Whittier Creek Mitigation Project

Year 1 (2022) Monitoring Report

Subject: Response to DMS Comments for Draft MY1 Report Review
Whittier Creek Mitigation Project, Surry County
Yadkin River Basin: 03040101
DMS Project #100020, DEQ Contract #7182

Please find enclosed our responses to the NC Division of Mitigation Services' review comments dated December 16, 2022 in reference to the Whittier Creek Mitigation Project's Draft MY1 Report. We have revised the Draft document in response to the referenced review comments as outlined below.

**Figure 3. Current Conditions Plan View
Monitoring Year 1
Whittier Creek Mitigation Project (#100020)
Surry County, NC**

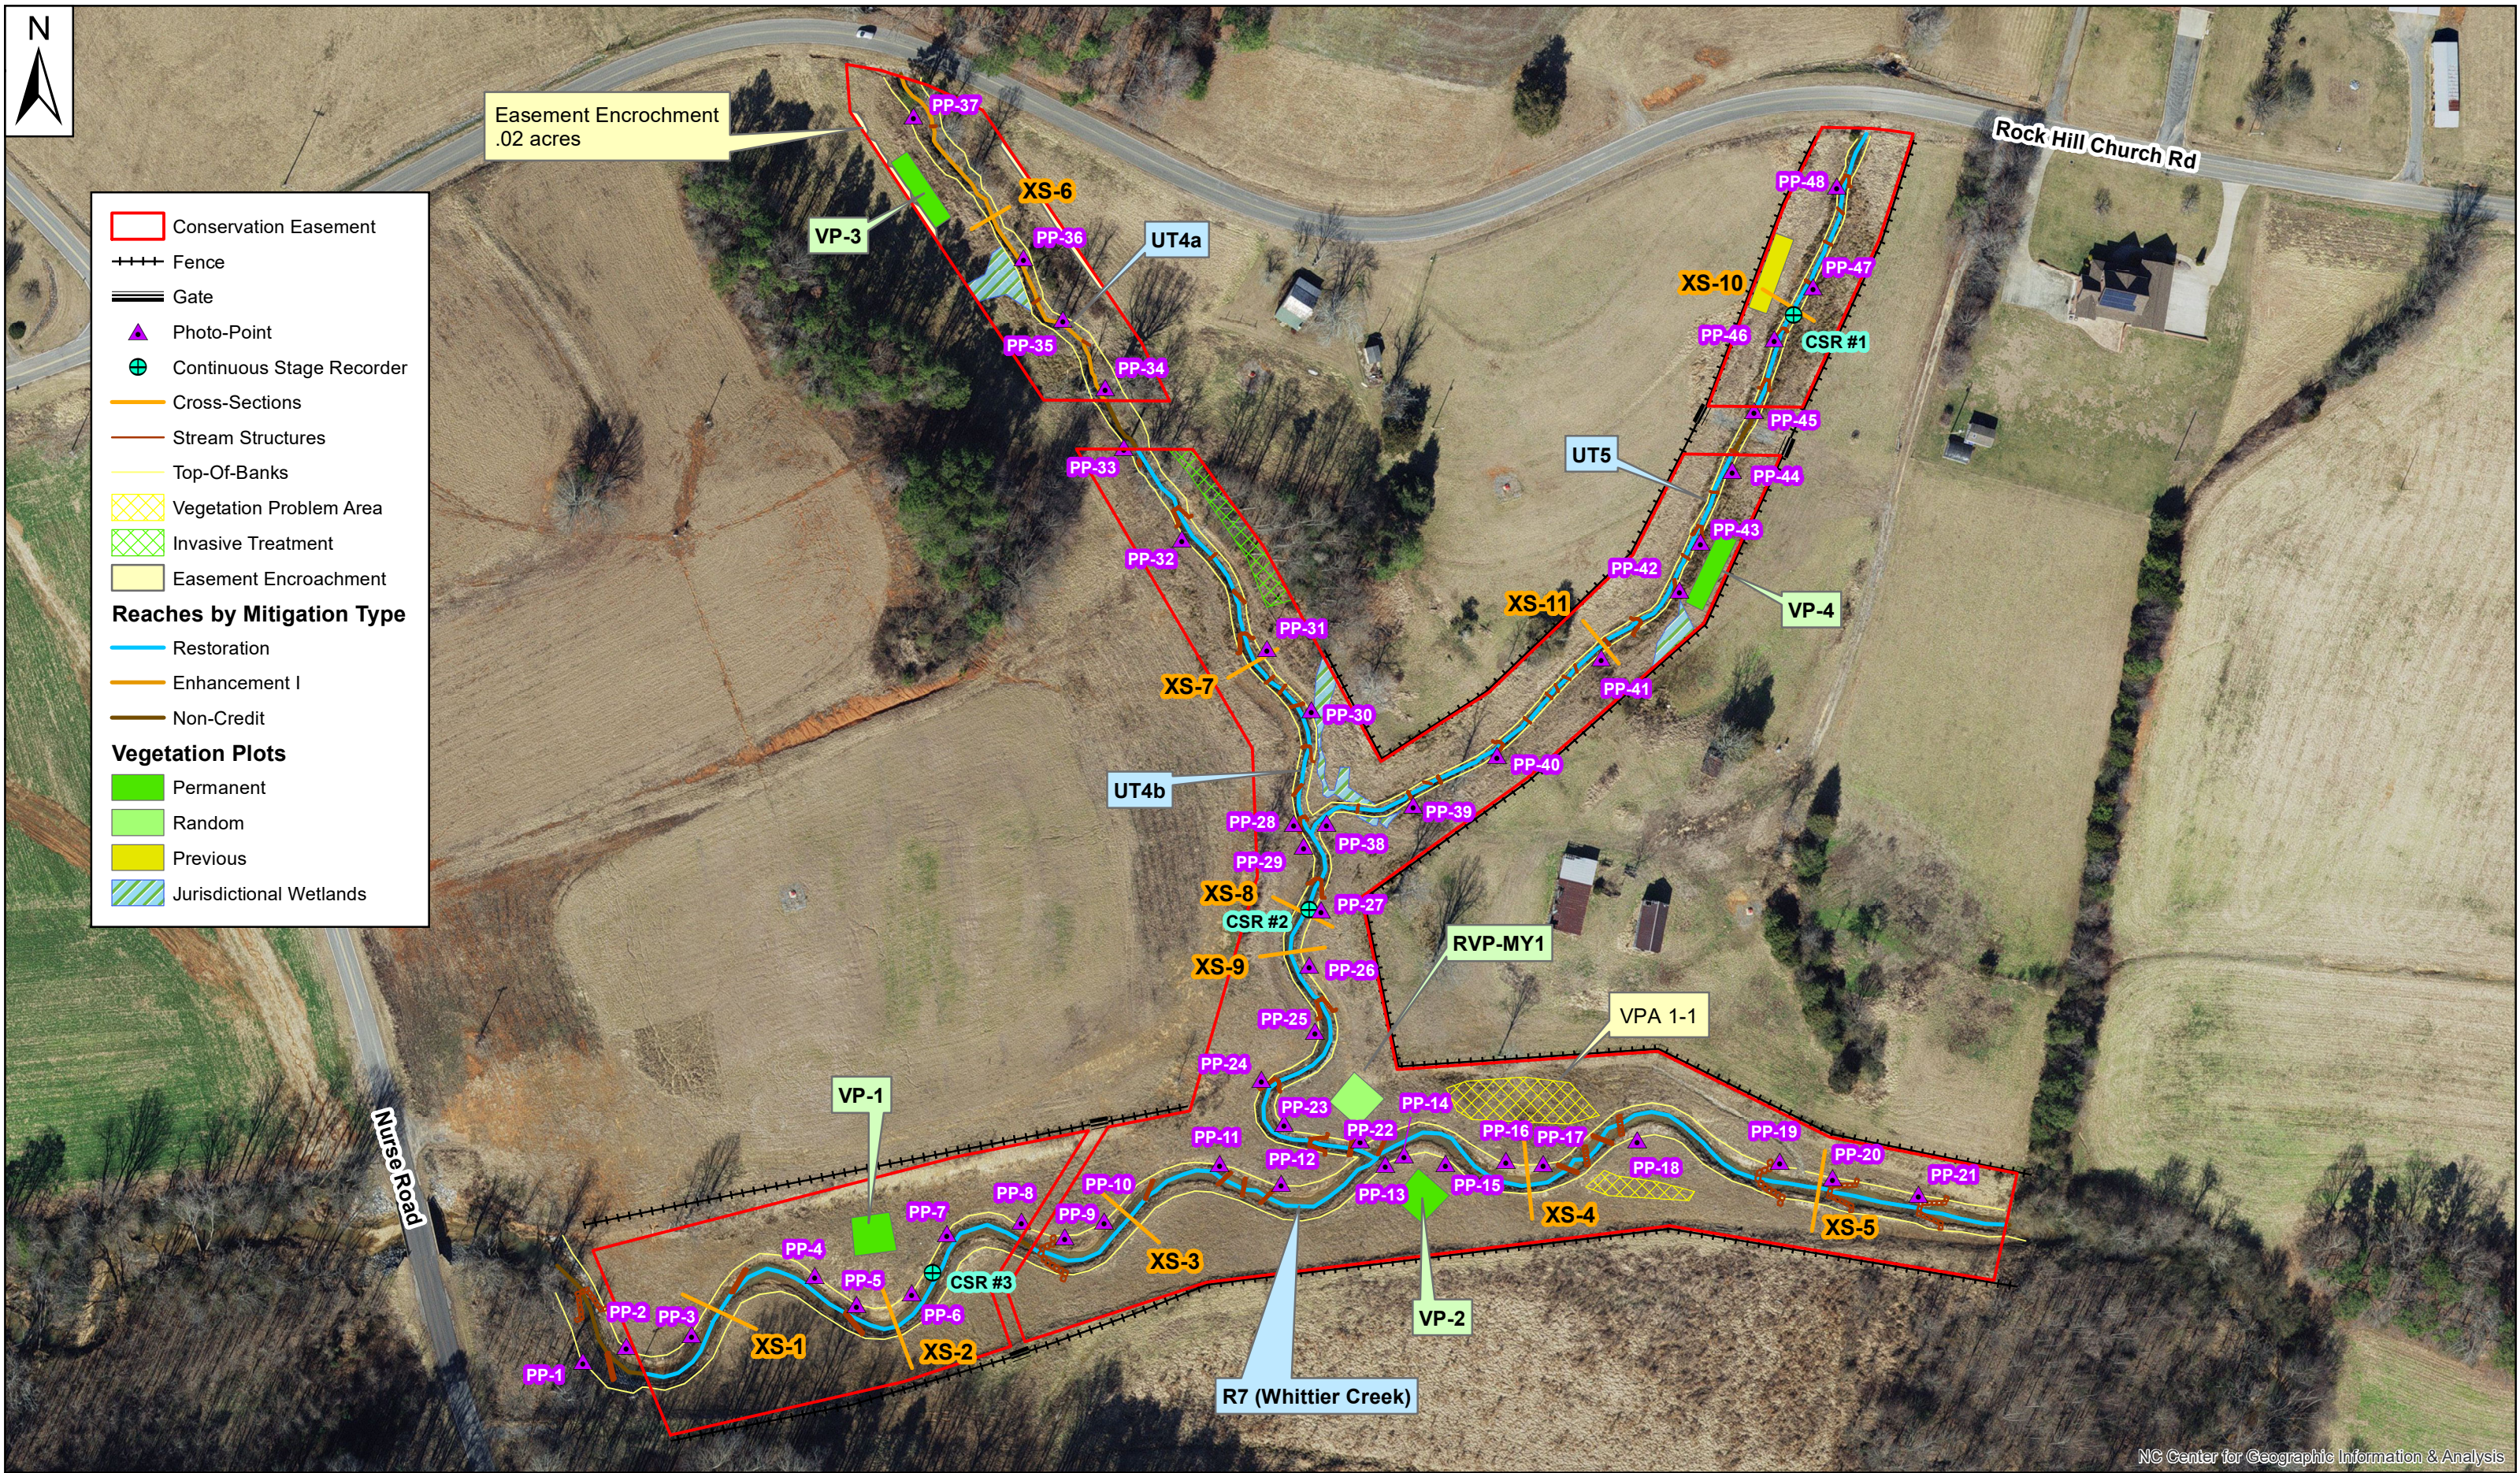
- 1.4 Monitoring Result and Project Performance: Flow gauge (WCFL1) is discussed in the section. This gauge is labeled differently throughout the report. CCPV and photo on page 26 refers to gage as CSR1, Figure 6 refers to gauge as in-channel flow gauge 1 and Table 11 uses WCFL1. Please update report for consistency. Is this gage different than the two other continuous stage recorders installed on the site?

Response: To be consistent throughout the report, Michael Baker has renamed all gauges to continuous stage recorder (CSR) 1,2, and 3. All revisions have been made to table 10 and figure 5.

Permanent Cross-Section 3
Year 1 Survey Collected: November 2022

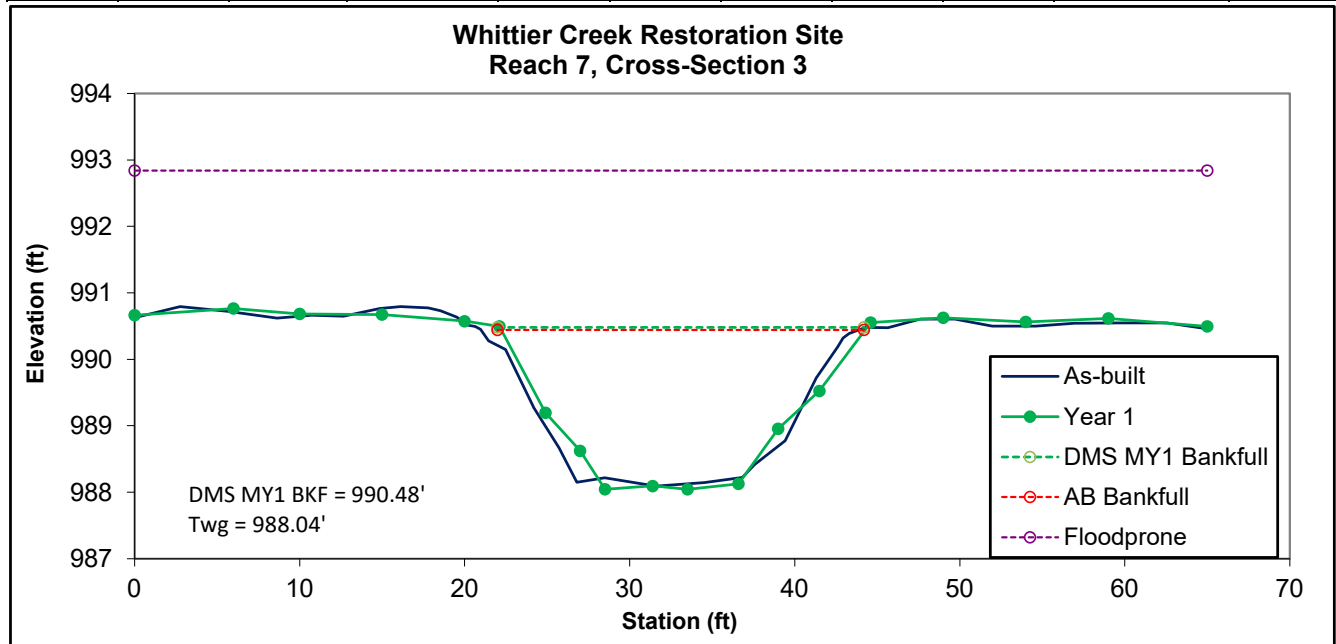
- Cross Section 3: Please add note regarding bank height ratio calculation as shown on other riffle cross section graphs.

Response: Revision made as requested.

Figure 5. Bankfull Event Graphs

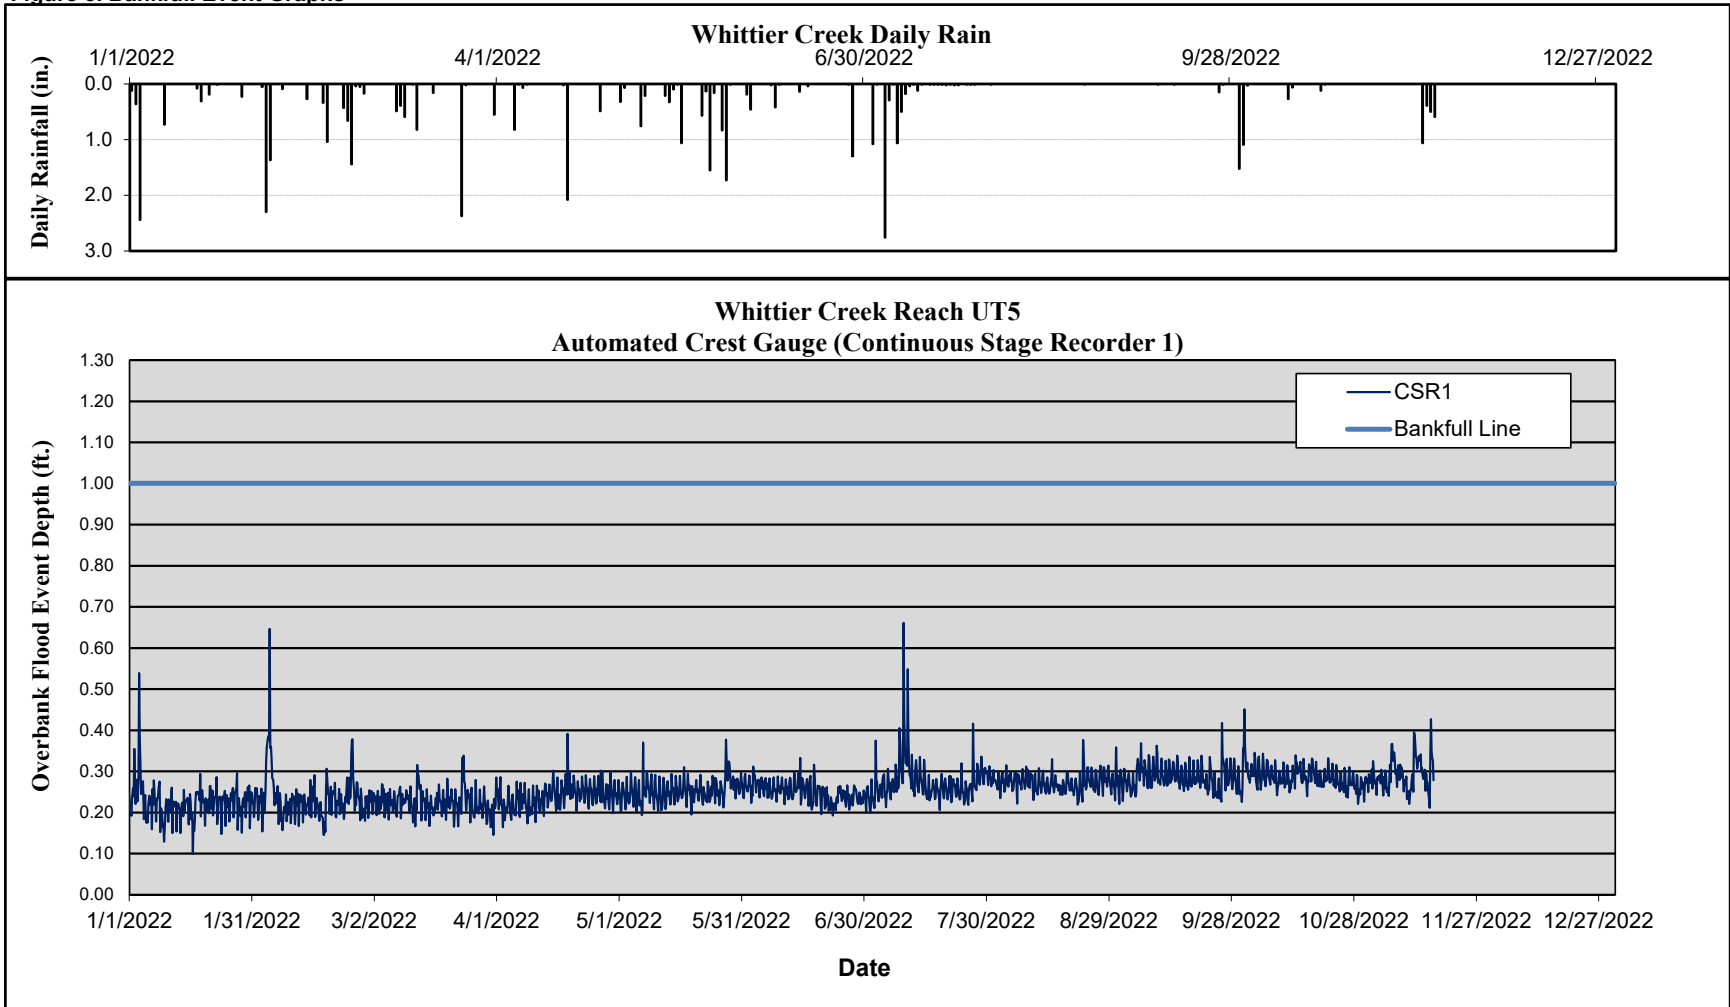
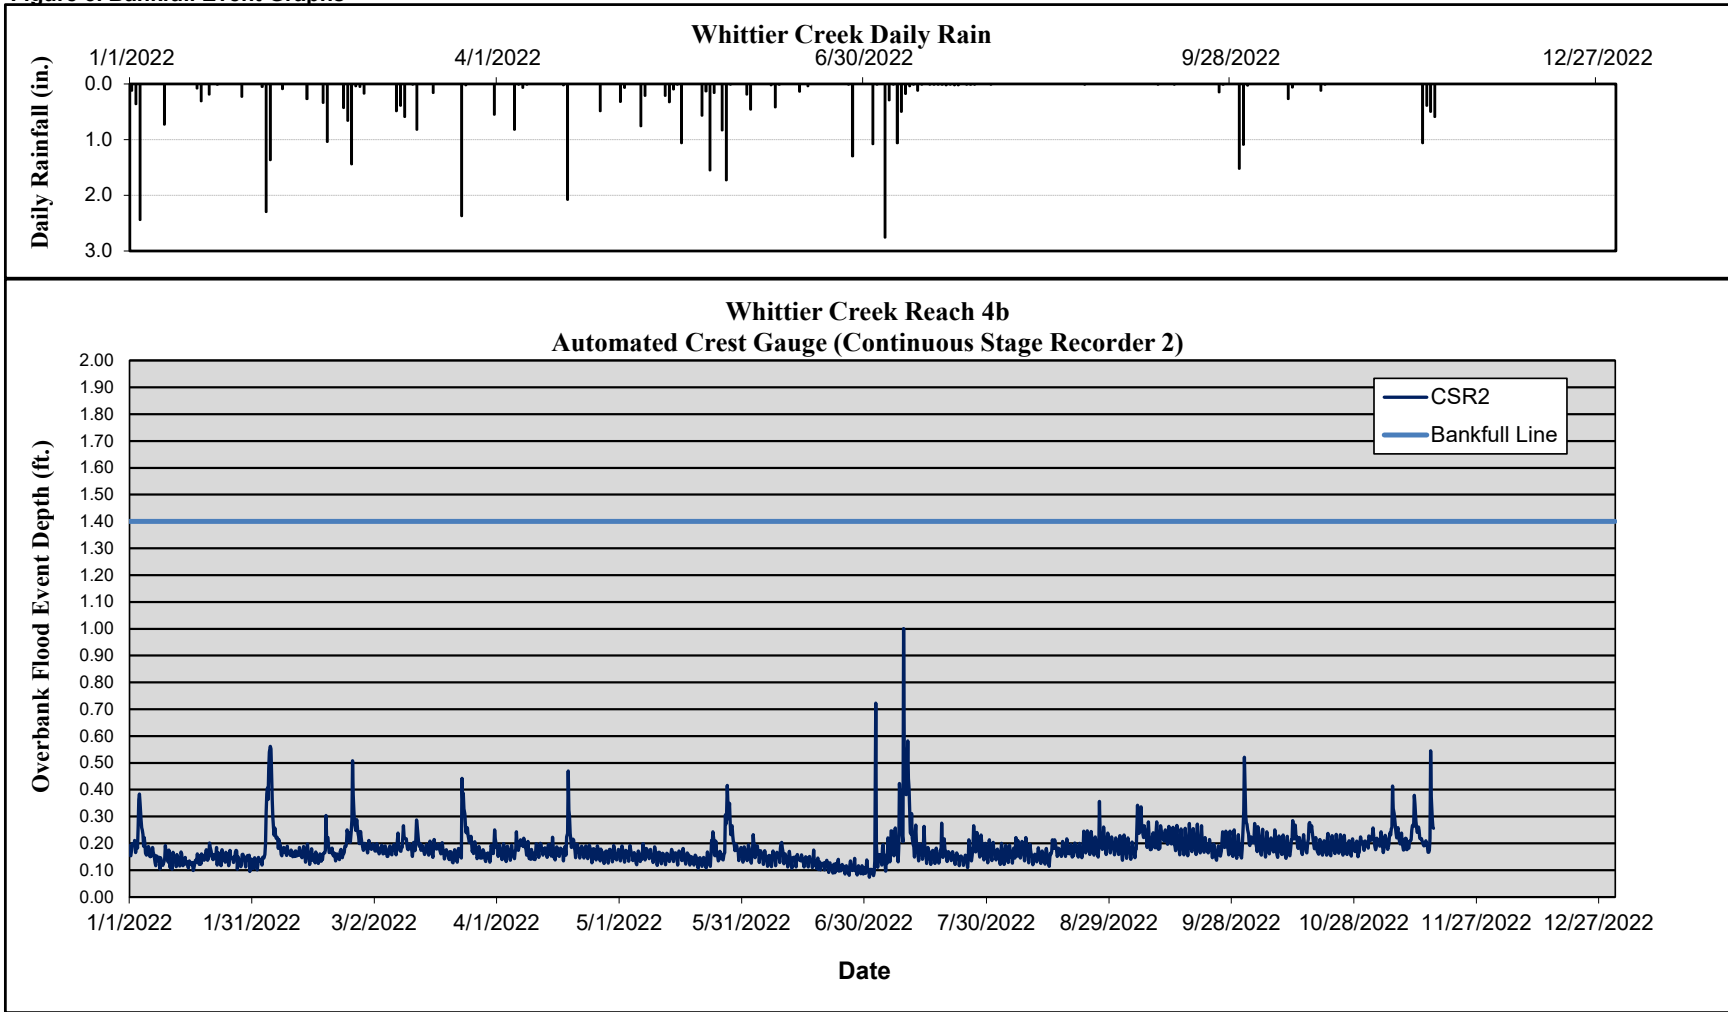
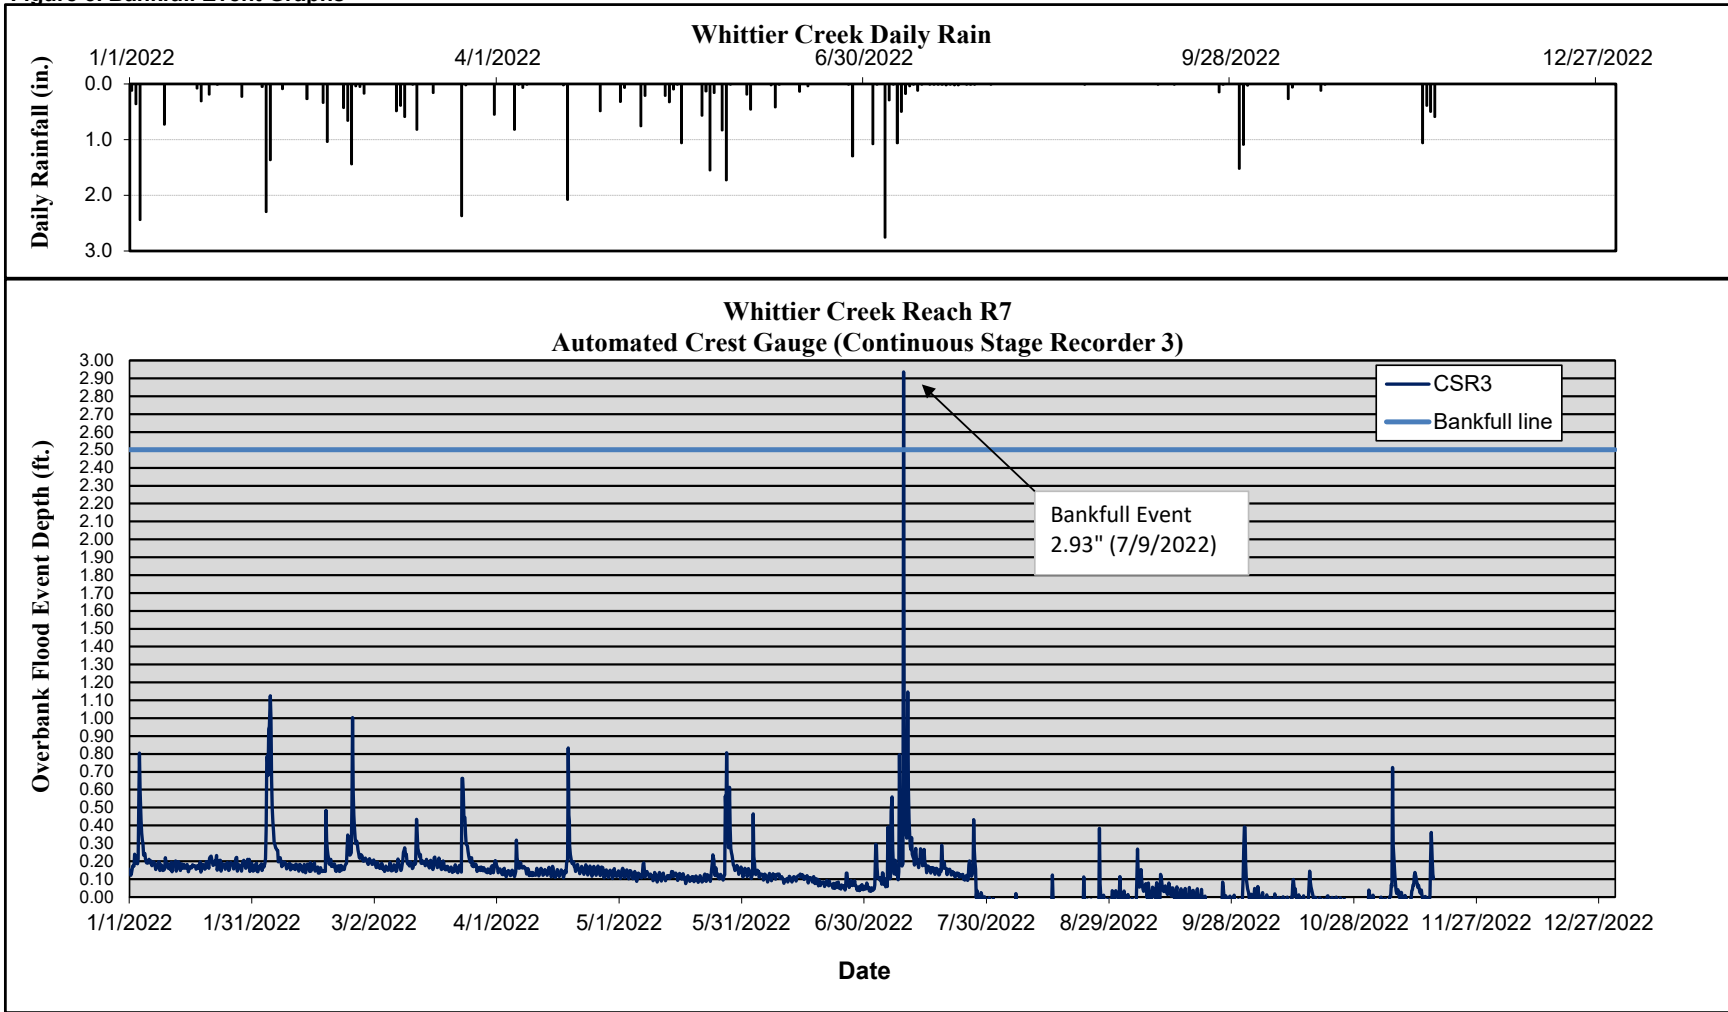
- Figure 5: Please refer to “surface water gage template” (attached) for required graph information. Graph is missing several key pieces of information: bankfull elevation, thalweg elevation, etc.

- Figure 5: Please update graph titles and refer to the reach and gage names how they occur within tables, CCPV and text for consistency. For example, one graph currently shows Whittier Creek Reach 4b Automatic Crest Gauge (Continuous Stage Recorder), but on the graph it is labeled as WCCG1. This should be UT4b – CSR1 or something similar.

- Figure 5: Please print all Figure 5 graphs in landscape for final.

Response: Additional information have been added to the graph as requested.

Response: Revisions made as requested.

Response: All Figure 5 graphs have been changed to landscape as requested.
